City of Portland
City Council

Appeal - Type III Land Use

LU 20-123610 DZM

NW 23rd & Marshall

1. Bike Parking – Stall Widths (33.266.220.C.3.b).

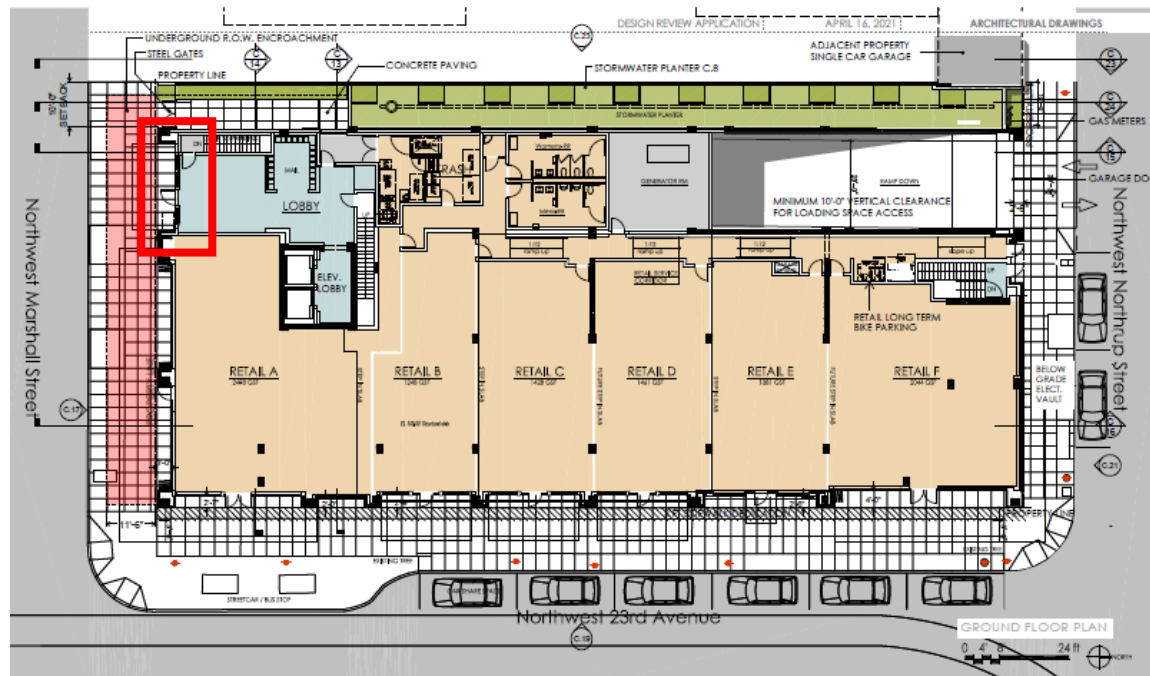
The Proposal: Request to reduce the width of the vertically hung bike parking spaces from 24” to 18”, with an 8” vertical stagger.

Staff supports

2. Transit Street Main Entrance – Location (33.130.242.C.3.c)

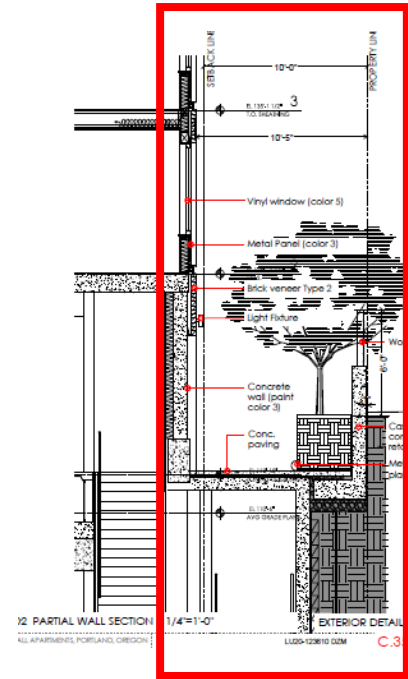
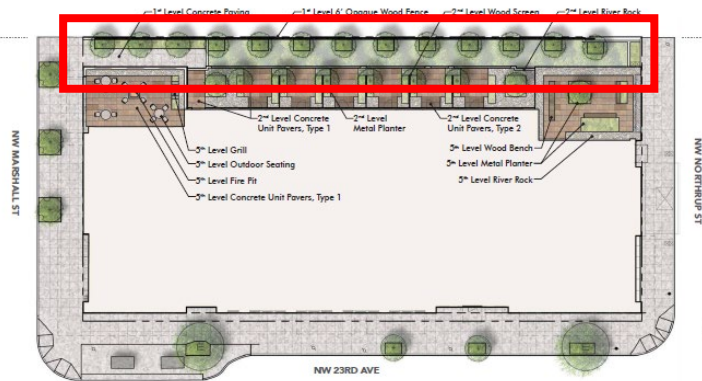
The Proposal: Request to locate the proposed main entrance to the residential portion of the building on NW Marshall, approximately 70 feet from NW 23rd Avenue (transit street).

Staff supports

3. Setbacks – L3 Landscape (33.130.215.B.2.b)

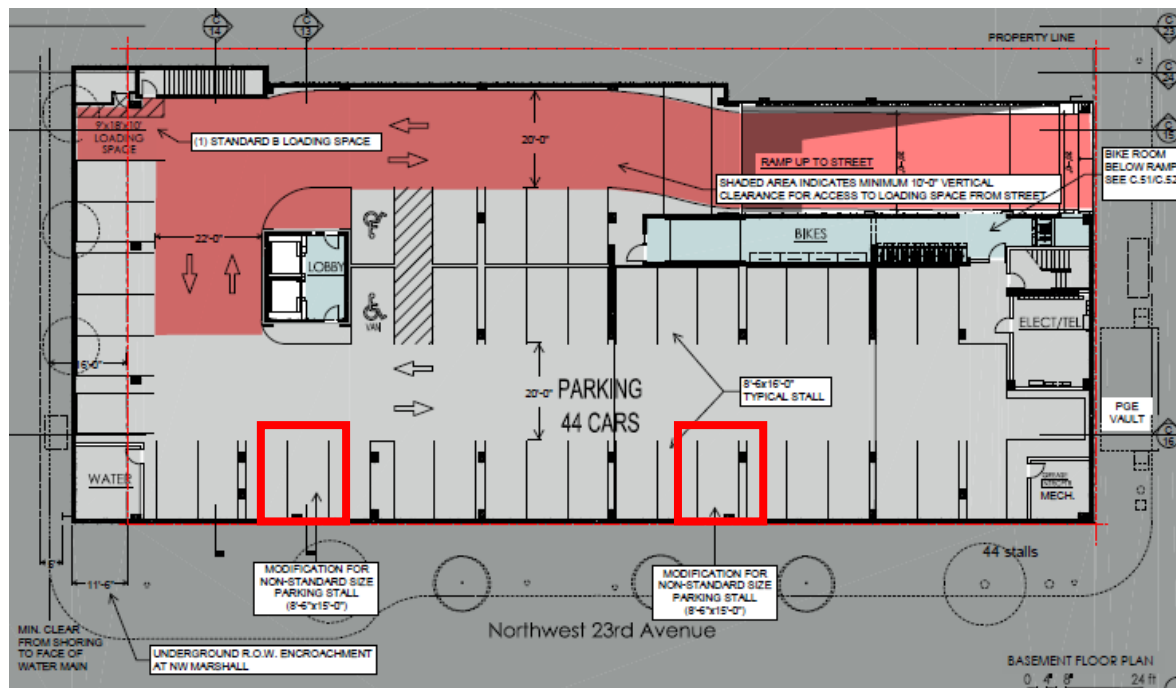
The Proposal: Request to alter the required L3 landscape screening to the west wall due to substantial grade differences.

Staff supports

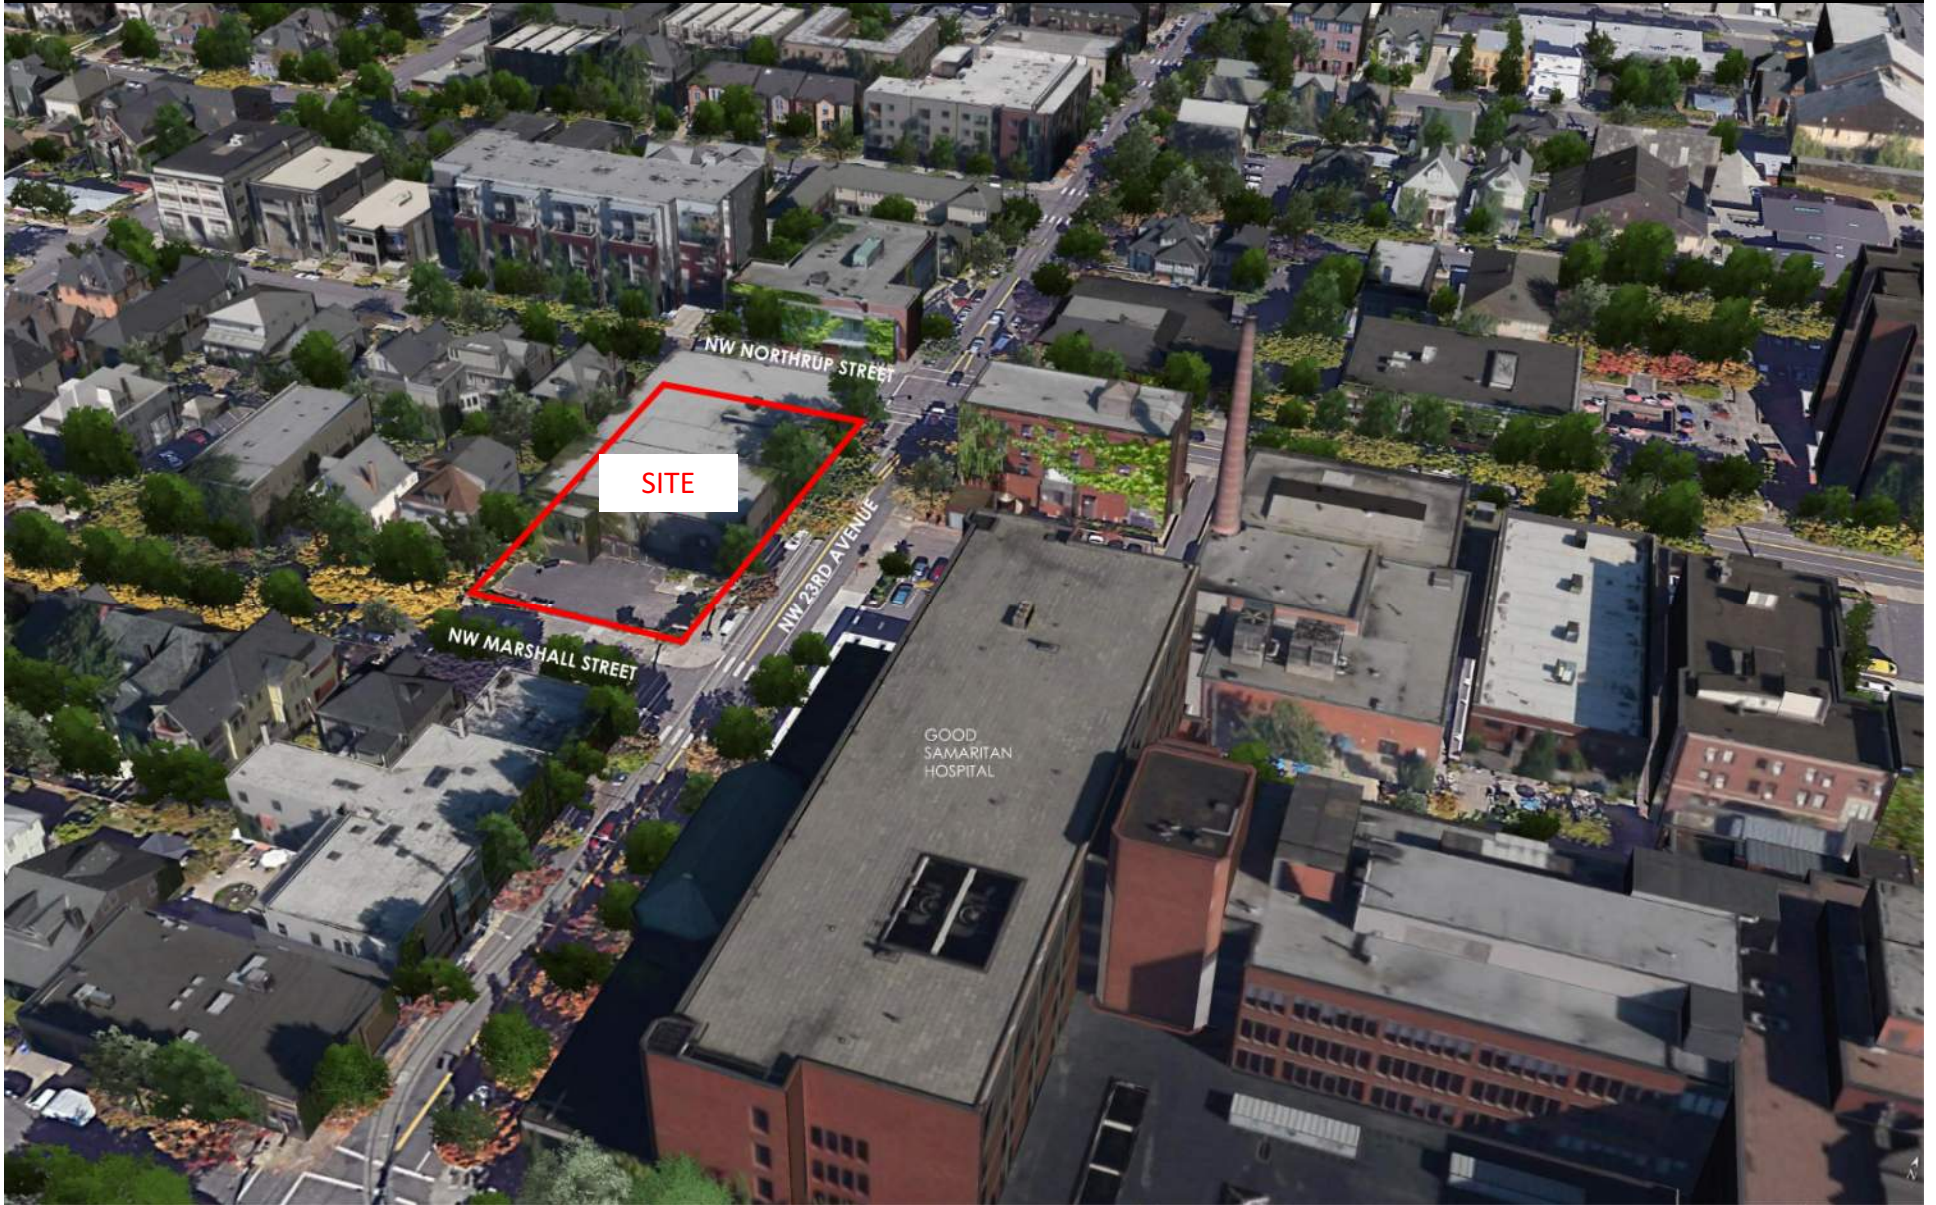
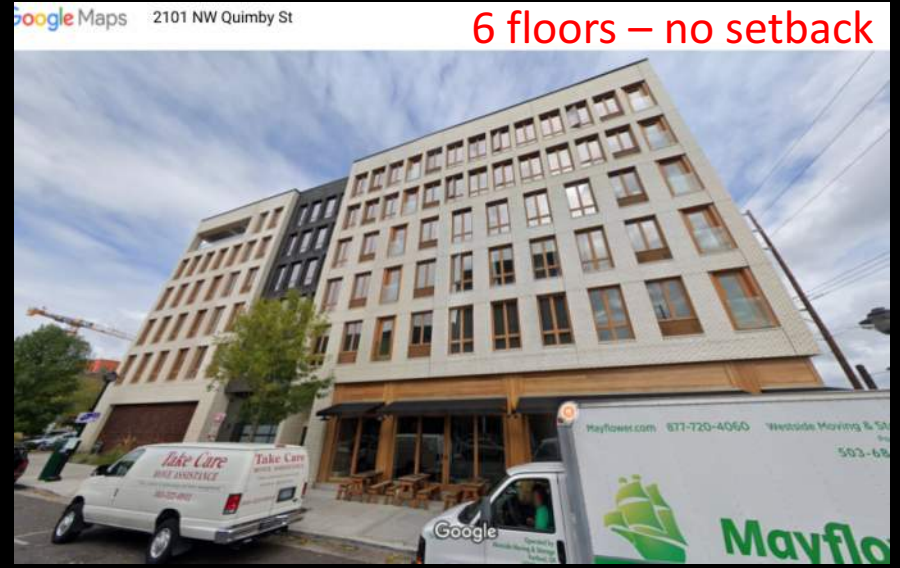
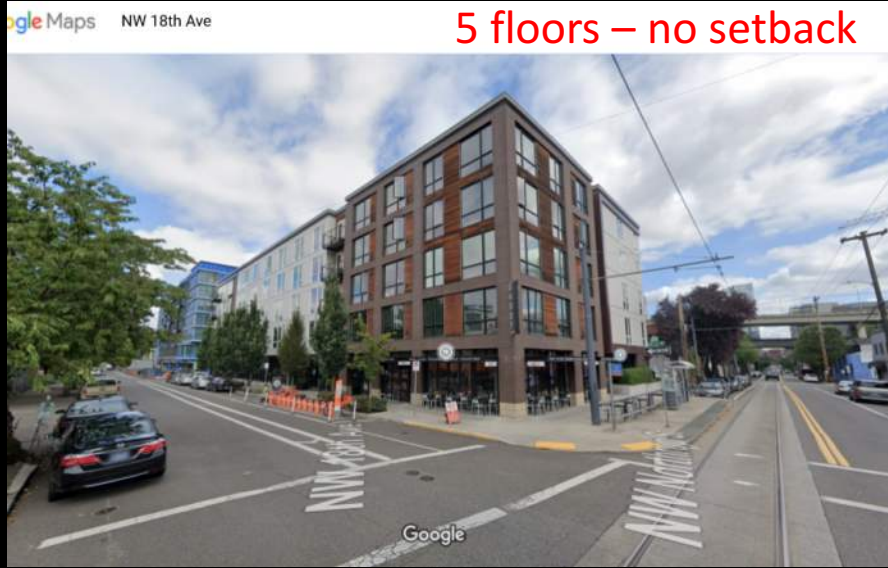
Staff Finding: In this case, the building is over 4 stories but is not stepped back from NW 23rd. Given this building located in the middle of NW 23rd, it faces the streetcar as well as the larger Good Sam across the street, and most of the massing has appropriately been set to the east away from the smaller-scaled residential zoned area to the west, staff considered the 5-story massing facing NW 23rd appropriate for this specific site.
